CNL-14-009

Subject: Response to NRC Request for Additional Information Related to Review of Potential Breaches of HESCO Modular Flood Barriers and Earthen Embankments Affecting the Updated Hydrologic Analysis Results for Sequoyah Nuclear Plants, Units 1 and 2, and Watts Bar Nuclear Plant, Unit 1

RESPONSE TO NRC MECHANICAL AND CIVIL ENGINEERING BRANCH (EMCB) REQUEST FOR ADDITIONAL INFORMATION (RAI)

1,000 Ton Barges - Random Release HESCO Concertainer Impacts
(Solid pink represents the HESCO Concertainers, other colors represent varying river velocities)

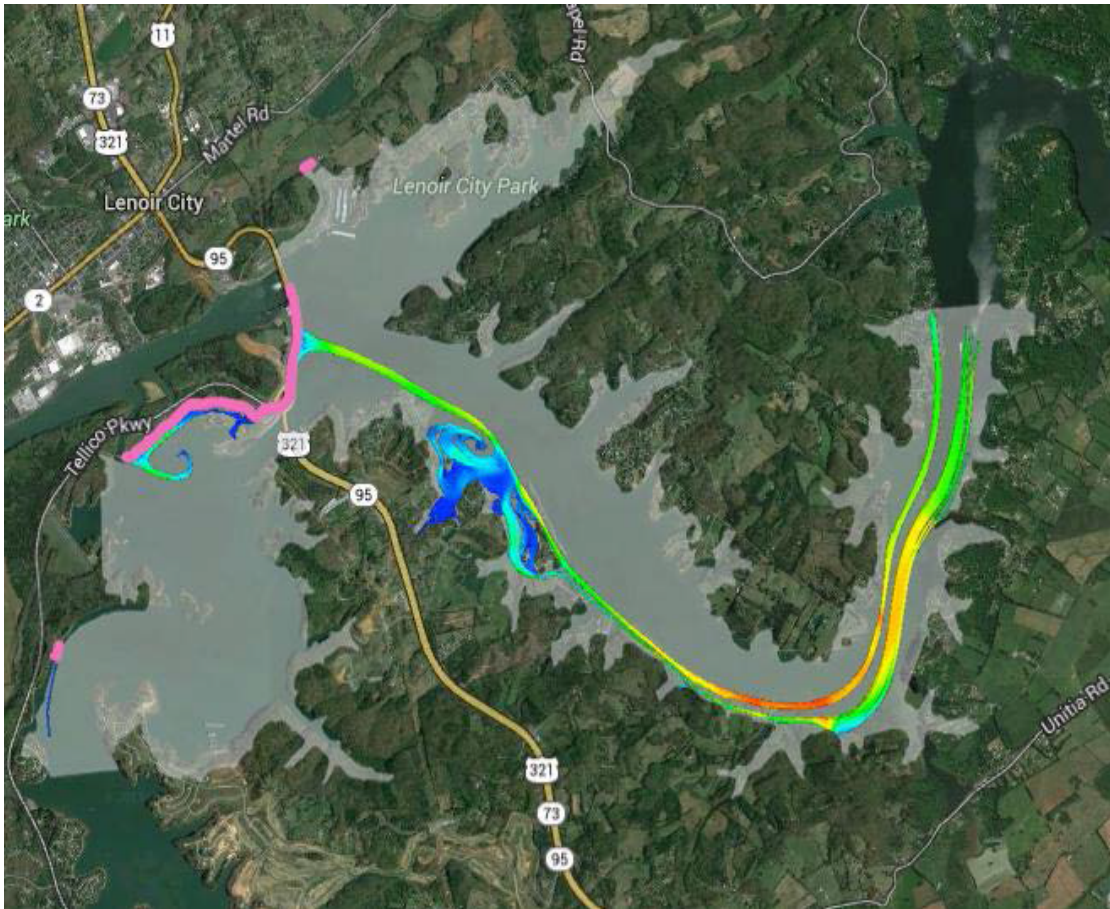
Please provide additional information regarding the particle seed location and the use of other post-processing results that lead you to reach this conclusion. Regarding the seed location, the response should describe if alternate seed locations were considered in the reservoir. Regarding other visualization/post-processing methods, please state if inverse particle tracking methods were considered for use. For example, inverse particle tracking techniques could be used to determine where the particles (i.e., barge surrogates) would need to originate (i.e., moored and released) in order to have them approach the HESCO barriers during the PMF event.

The following figures are a product of the random location simulations and provide a representation of barge origination locations that result in HESCO Concertainer impact in the enhanced simulation.

For the 1,000 ton barges, some releases near the inlet of the domain result in impacts on the HESCO Concertainers. These releases are close to the FCH_TN2 release point from which the analyses indicate no impacts would occur. The primary difference is the stream velocity associated with the simulated release. The release for the specified location (FCH_TN2) is associated with a zero velocity, while the random release location is associated with the local stream velocity.

Barge Trajectories (Release from FCL_TN)
(Solid pink represents the HESCO Concertainers, other colors represent varying river velocities)

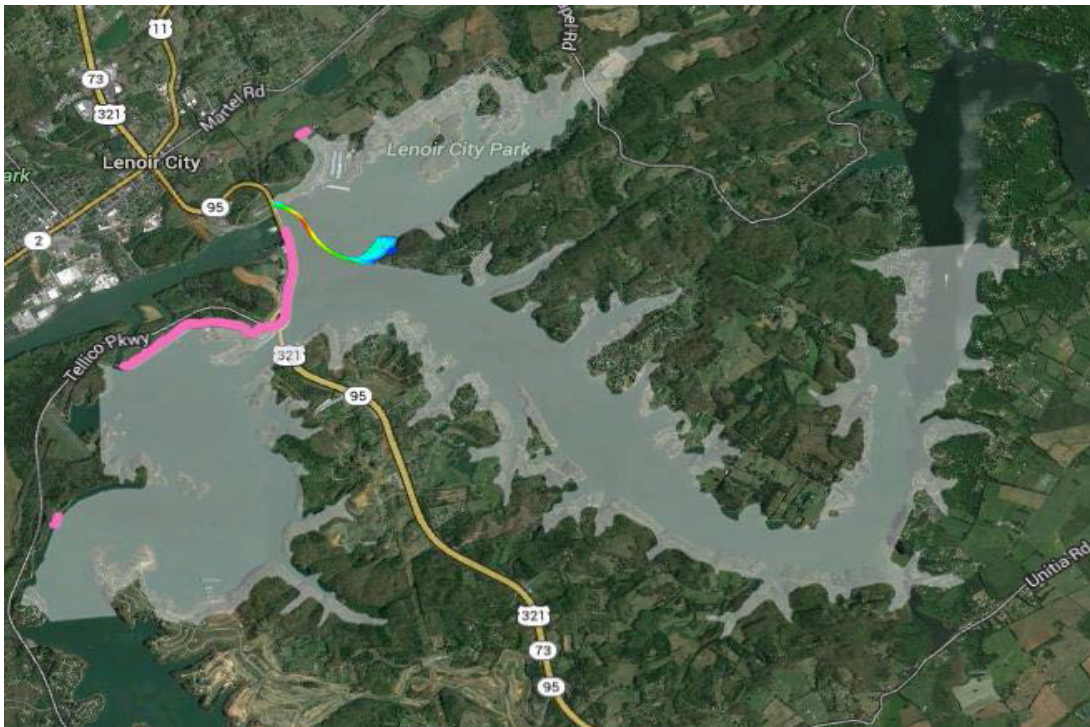
In Figure 19 of the Reference, it is not clear what the caption or the image is trying to convey. The caption states that 17% of the modeled sphere beaches [sic]. If this is assumed, then 83% of the modeled sphere would then continue in the flow path. However, a typical barge that is flowing uncontrolled would flow as a unit. Please clarify the perceived discrepancy in this analysis.

Figures 18 and 19 of Reference 1 represent the result of releasing those 400,000 particles (simulated barges). The results show that considering 400,000 (modeled spheres/particles) uncontrolled barges, none of the barges pose a threat to the HESCO barriers, with most of the barges (83% probability) impacting Fort Loudon Dam. The remaining barges (17% probability) are projected to beach on the shoreline adjacent to the first class landing at RM 603. Figure 18 (Reference 1) depicts the 83% that impact the dam and are entrained in the flow that naturally exits the dam, following the narrow streamline shown. Figure 19 (Reference 1) depicts the 17% that are projected to beach adjacent to the first class landing at RM 603.

Figures 18 and 19 in the Reference 1 submittal represent the release of 400,000 objects weighing 1,000 tons each from the first class landing near Fort Loudoun dam (approximately TRM 603) designated FCL_TN in the more recent enhanced simulations. The enhanced simulation released 375,000 particles from the same location and also concluded no impacts with the HESCO barriers would result (shown below).
